**SERVICE INSTRUCTION MS 6/99E Rev A**

Utfärdare Issued by Aussteller <b>Bertil Nyström</b>	Datum Date Datum <b>1999-11-22</b> <b>Rev 2005-08-29</b>	Produkt Product Produkt <b>Scando Super FC / C</b>
Från maskin nr. From machine No. <b>All</b> Von Maschine Nr.	Till To - Zu	Berör/Concerns/Betrifft <b>Splines connection between motor and gear box</b>

**This revision replaces Service Instruction MS 6/99E dated 1999-11-22.**

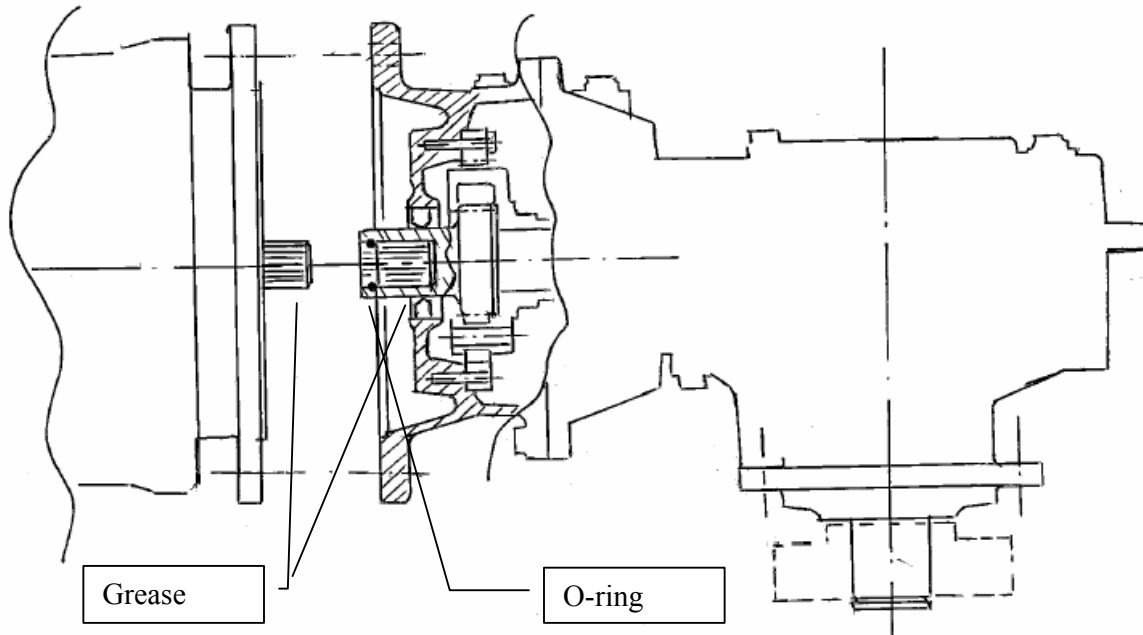
**To avoid initial corrosion and later wear of splines connection between motor shaft and gear box, the motor shall be dismantled and the outer splines on motor shaft and the inner splines on the gear box pinion shall be greased with high quality grease.**

**O-ring 34 X 3 mm shall also be changed**

**Grease type Shell SRS 4000**

**Greasing interval every 24 months**
